Release Note 5.42.1.6.26R50(20230714)

Models and Firmware

fwV10.rom: CIP280V2

• fwV20.rom: CIP290V2

Preview

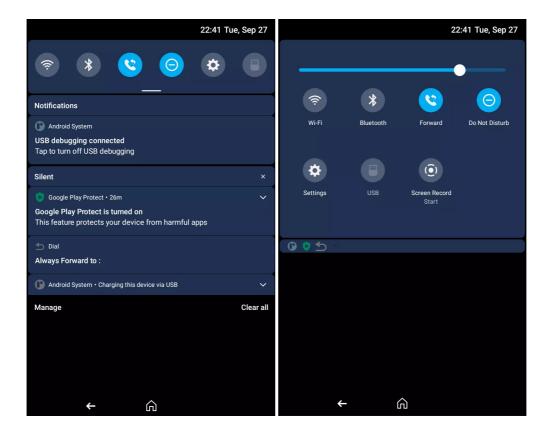
- Support for moving app icons by drag and drop.
- Support App Widget.
- Support live wallpaper(need a 3rd party app).

- Redesigned the UI, including icons, interactions, and visual presentation to provide more smooth operation.
- Redesigned the status bar to provide more clear view of status.
- Redesigned the system setting module to provide more convenient management settings.
- Improved the appearance of pull-down menu, and adjusted the content.
- Improved the support to 3rd party app, like the better compatibility between pull-down menu and 3rd party app.
- Improved the experience of multi calls.
- Enhanced the usage of Line Keys to let you to view, configure, and use them more directly.
- Enhanced the video performance to provide more smooth video call experience.
